August 21, 2016

Re: Bicycling Connectivity Improvements – Stanley Park Causeway South End

Figure 5 - Proposed Gateway Node (SPCP Recommendation 12A)

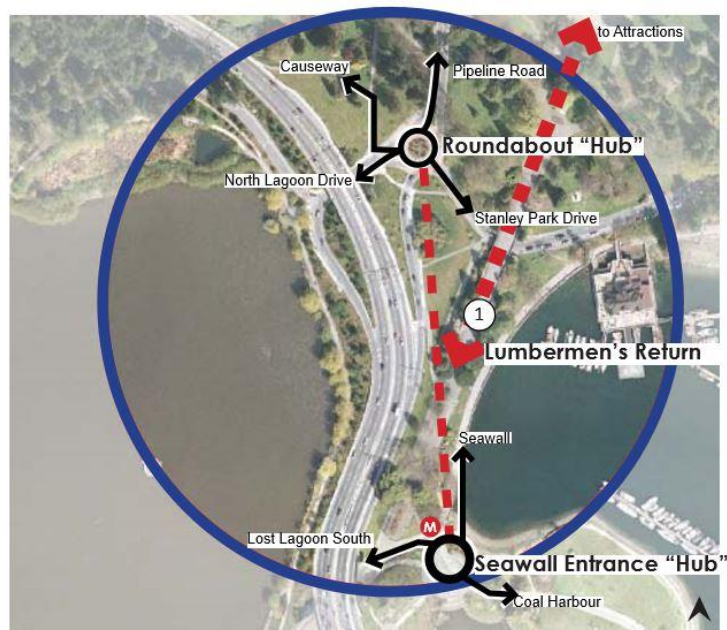
Improvements to this area of Stanley Park were recommended in the Stanley Park Cycling Plan (SPCP) in 2012, with prioritized recommendations. A significant recommendation was made to implement a Gateway Node (SPCP Issue #12, Recommendation 12a). Lack of connectivity in the park was a major theme in the Cycling Plan. The concept of the Gateway Node is shown in Figure 5.

Without implementing all of this recommendation, providing a connection from the southbound Causeway bicycle path to the Seawall Entrance Hub, and a similar connection from the Seawall Entrance Hub to the northbound Causeway bicycle path, would be a great step forward. These changes do not result in additional paved space in the Park, they are low cost, and they would improve safety for both people on bikes as well as people walking in the Park.

The route suggested in this proposal (indicated in Figure 1 by a red line running from point A to Point E) generally follows the alignment recommended in the above Gateway Node concept from the Stanley Park Cycling Plan. The route is currently being used by many people on bikes, and thus represents a desire line, but is not legal due to the lack of permitting for people on bikes to use the existing paved paths. This is despite the fact that the paths are wide and do not present risks of pedestrian conflict.
